National Transportation Safety Board

Urgent Safety Recommendation

Date: October 21, 2004

In reply refer to: H-04-32 and -33

Figure 1. Signage at approach to USBP checkpoint on February 22, 2004.

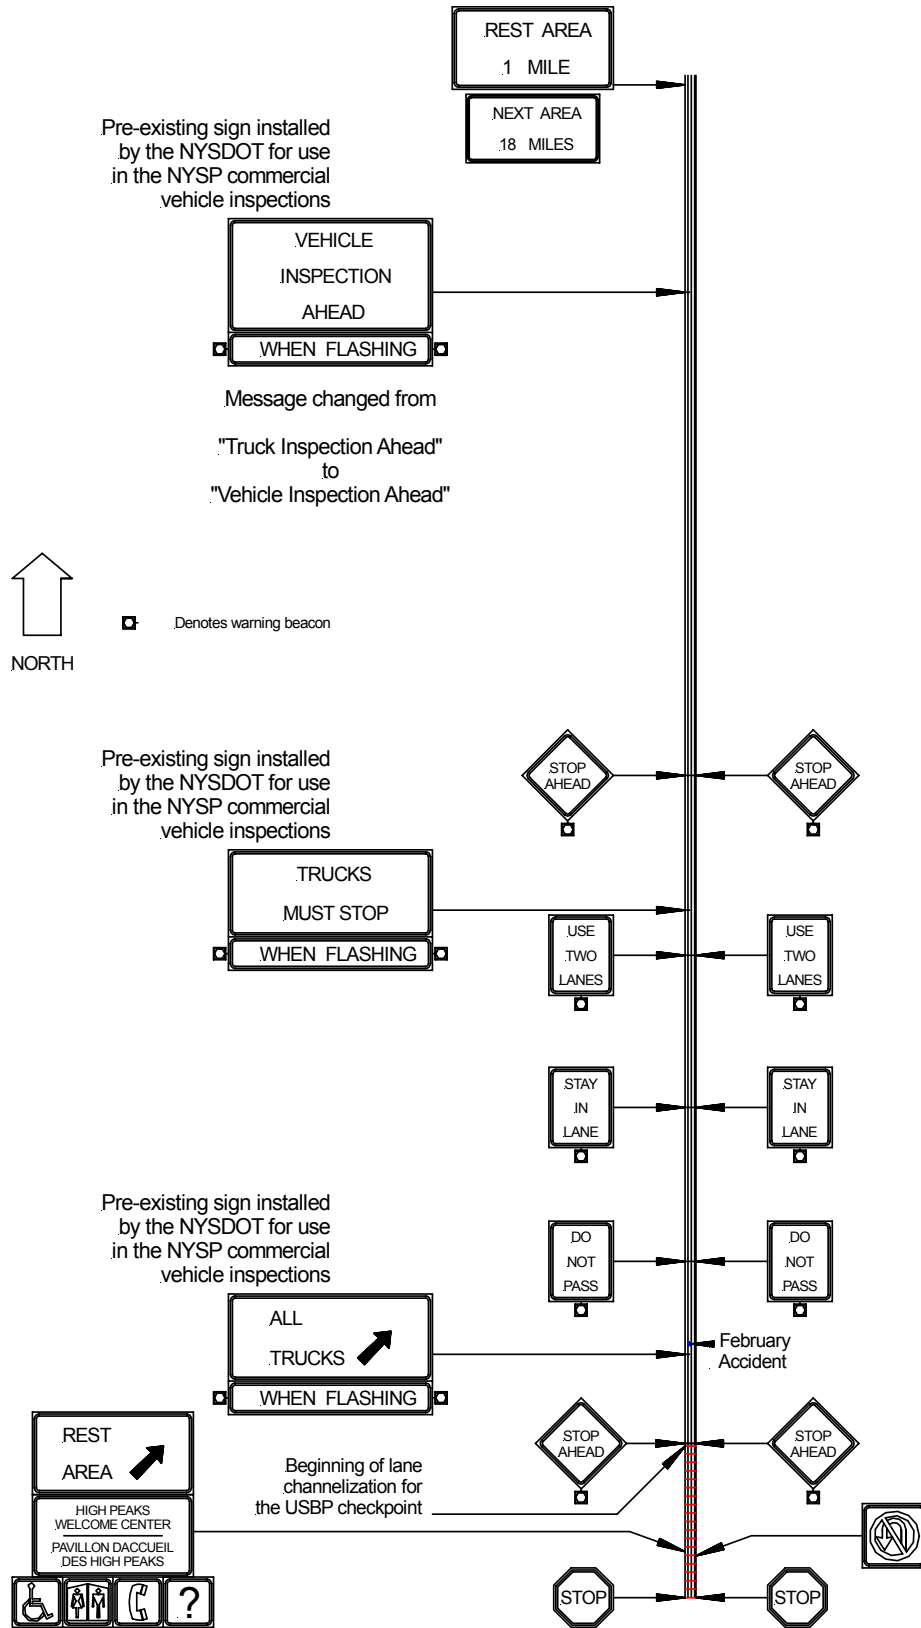
In addition to the USBP, the New York State Police (NYSP) uses the High Peaks rest area for commercial vehicle inspection and enforcement activities. The various uses of the facility resulted in a series of signs and flashing beacons being posted along the southbound interstate approaching the rest area (see figure 1). The first sign, “Vehicle Inspection Ahead When Flashing,” was located 4,631 feet (0.88 mile) before the checkpoint. None of the signs gave specific notice about traffic ahead being stopped in the roadway.

The *Manual on Uniform Traffic Control Devices* (MUTCD), maintained by the Federal Highway Administration (FHWA), is the national standard for all traffic control devices. Section 1A.02 of the MUTCD lists five requirements for effective traffic control devices; they must fulfill a need, command attention, convey a clear, simple meaning, command respect from road users, and give adequate time for proper response. Evaluated against these criteria, the traffic control devices at the North Hudson checkpoint were not effective. For example, the signage in place prior to the first accident did not clearly convey that traffic would be stopped ahead. One sign indicated “Vehicle Inspection Ahead When Flashing,” but the beacons were not flashing. Another sign indicated “Stop Ahead” and was immediately followed by one stating “Trucks Must Stop When Flashing,” possibly leading drivers of other vehicle types to conclude the stop did not apply to them.

Figure 2. Signage at approach to USBP checkpoint on September 19, 2004.

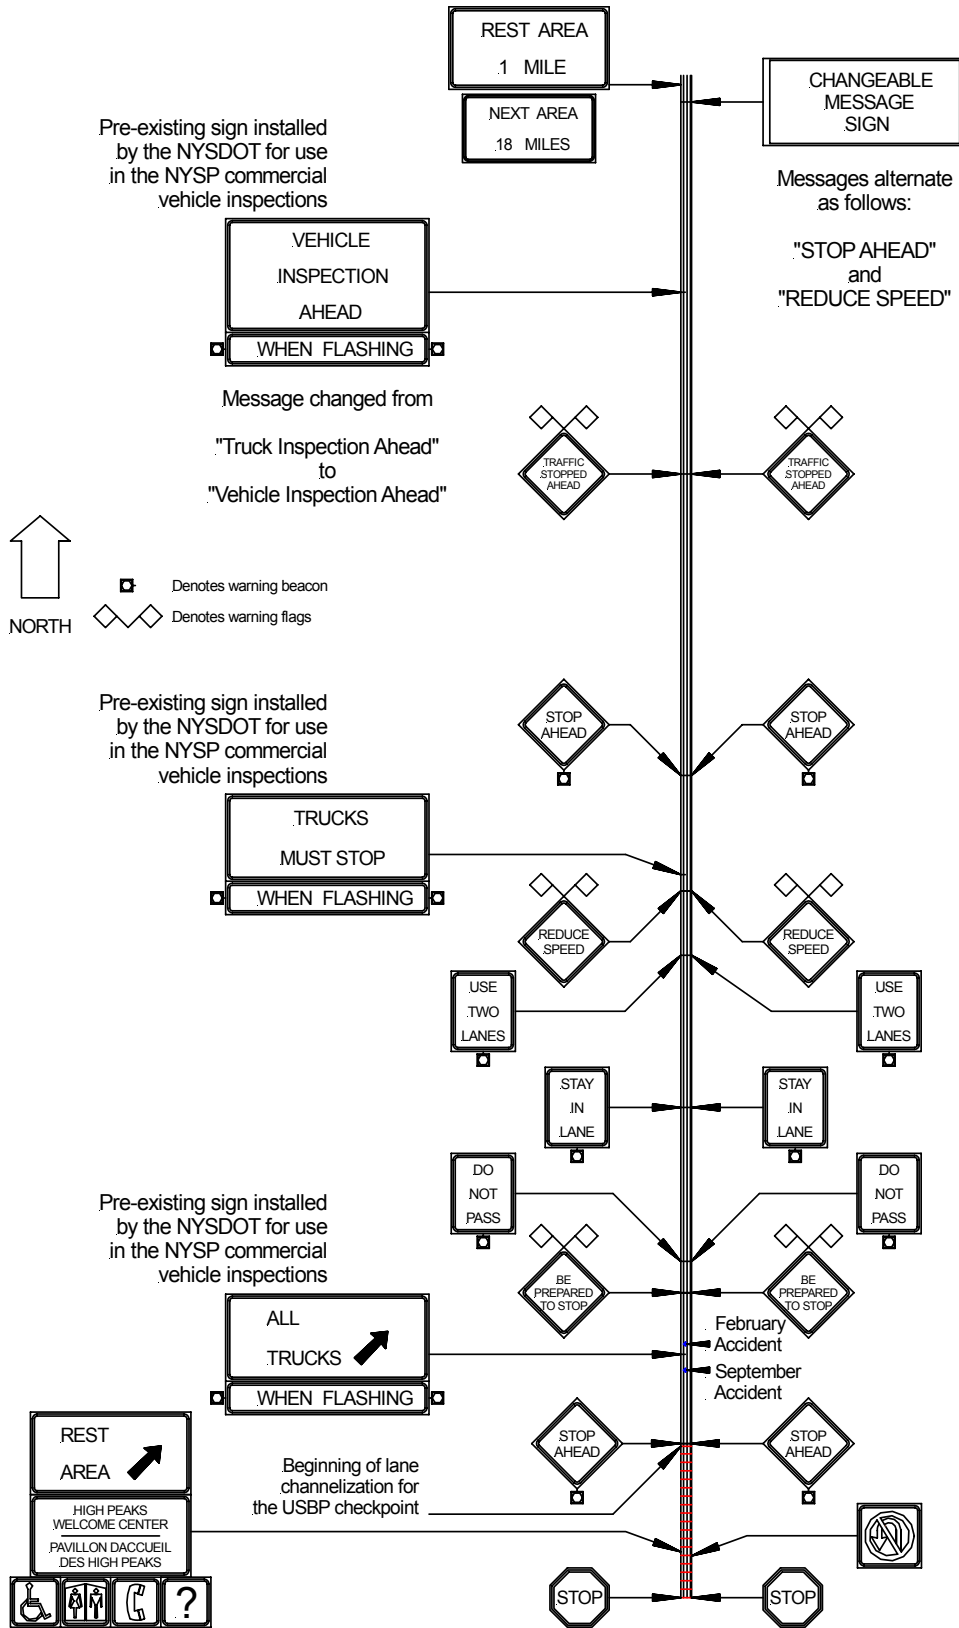
Following the February accident, the USBP and NYSDOT added signage along the approach to the rest area (see figure 2):

- Changeable message sign that alternated between “Reduce Speed” and “Stop Ahead” (in median 4,780 feet prior to checkpoint)
- “Traffic Stopped Ahead” (on right side of road and median 3,770 feet prior to checkpoint)
- “Reduce Speed” (on right side of road and median 2,330 feet prior to checkpoint)
- “Be Prepared to Stop” (on right side of road and median 913 feet prior to checkpoint)

The additional signage notified drivers that traffic might be stopped ahead but did not state where traffic might be stopped on the interstate for the checkpoint. The large number of signs—at least 25—may have been confusing to motorists.

Figure 3. Signage at approach to USBP checkpoint after September 22, 2004.

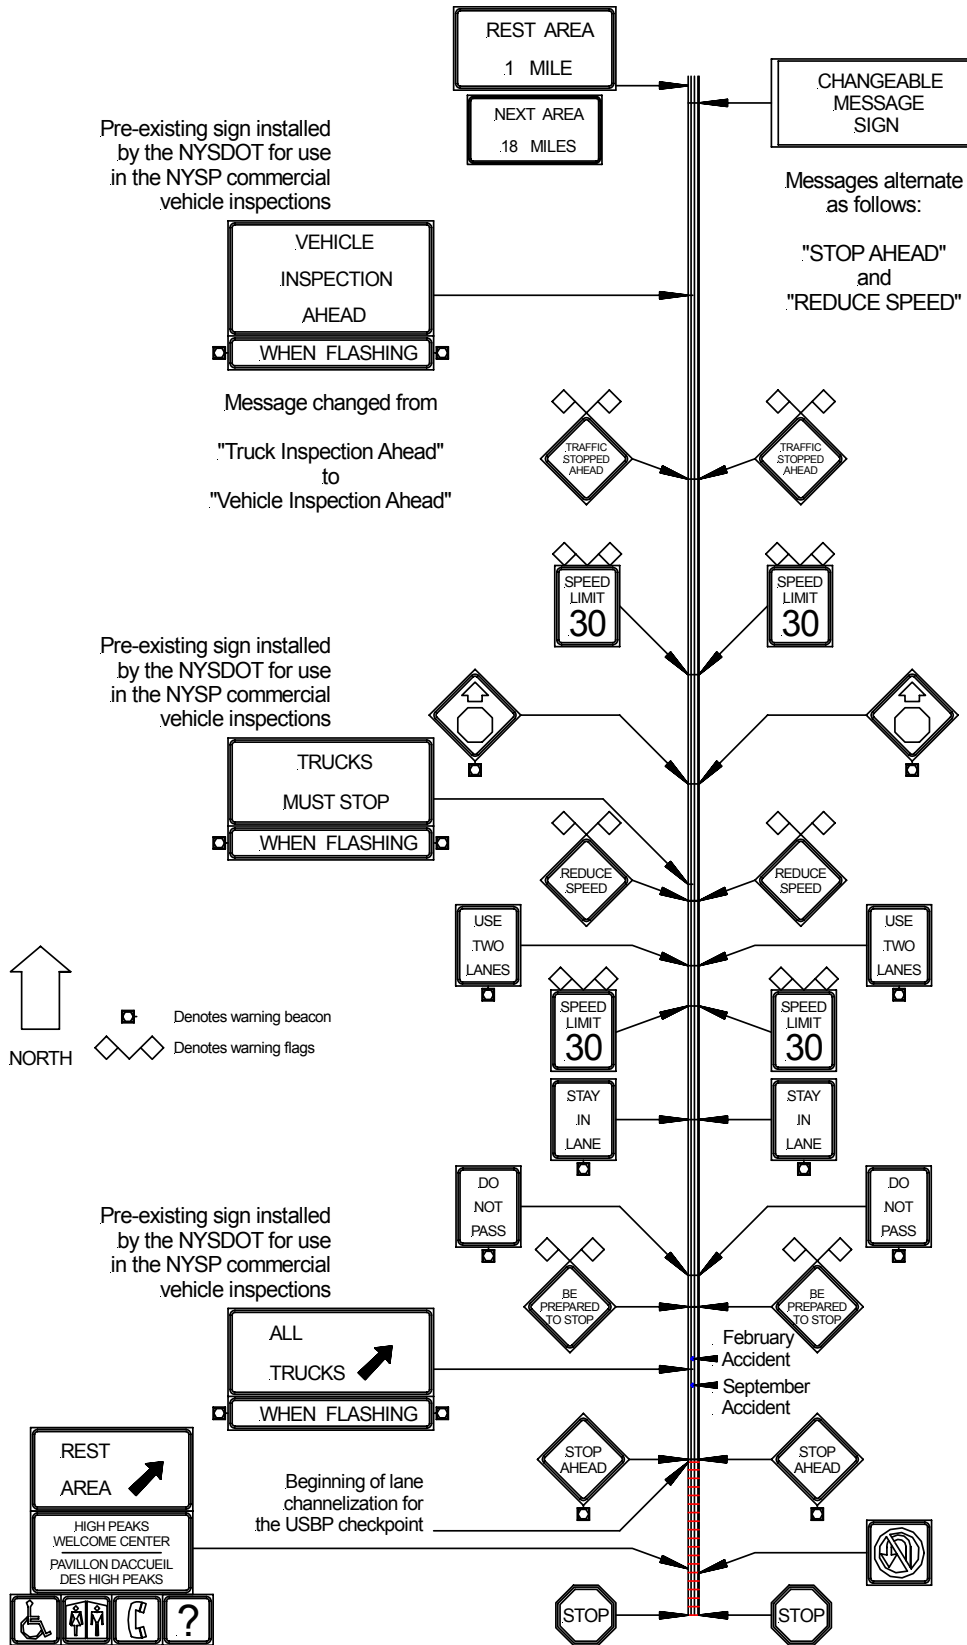
Following the September accident, the USBP and the NYSDOT again added signage (see figure 3; signs more than 5,280 feet from the checkpoint are not shown on the diagram):

- Changeable message sign that alternates between “Be Prepared to Stop” and “Stopped Traffic Ahead” (in median 2.6 miles prior to checkpoint)
- “Speed Zone Ahead” (on right side of road and median 2.2 miles prior to checkpoint)
- “Speed Limit 45” (on right side of road and median 2.0 miles, 1.8 miles, and 1.2 miles prior to checkpoint)
- Changeable message sign that alternates between “Speed Limit 45 MPH” and “Your Speed ___ MPH” (in median 1.1 miles prior to checkpoint)
- “Speed Limit 30” (on right side of road and median 3,300 feet and 2,138 feet prior to checkpoint)
- Symbol sign for stop ahead (on right side of road and median 3,036 feet prior to checkpoint)

This additional signage created a speed zone in which drivers are to reduce their speed from 65 mph to 45 mph 2 miles prior to the checkpoint and then to 30 mph 0.6 miles before the checkpoint. The NYSDOT also plans to install rumble strips about 1 mile prior to the checkpoint.

Following the second accident, the number of signs in less than 1 mile preceding the checkpoint increased to 29, resulting in an array of messages that was hardly simple and may have confused motorists. Section 2A.16 of the MUTCD cautions that “overloading road users with too much information is not desirable,” and researchers have found that many safety signs are not noticed in situations of high visual clutter.⁴ Although the USBP and the NYSDOT made a commendable effort to improve traffic control at North Hudson after the two accidents, they acted without the benefit of a systematic, comprehensive approach to traffic control in the area. The Safety Board concludes that the signage in place prior to the USBP checkpoint at North Hudson did not clearly convey adequate information to warn motorists that traffic on the interstate would be stopped ahead; the Board further concludes that the numerous signs added to that area following accidents in 2004 may lead to driver confusion due to information overload.

Assist the American Association of State Highway and Transportation Officials and the U.S. Bureau of Customs and Border Protection in immediately developing comprehensive traffic control guidelines specifically tailored to U.S. Border Patrol checkpoints located on high-speed arterial roadways. **(Urgent)** (H-04-32)

Incorporate, in cooperation with the American Association of State Highway and Transportation Officials, the guidelines referred to in Safety Recommendation H-04-32 into the *Manual on Uniform Traffic Control Devices*. (H-04-33)
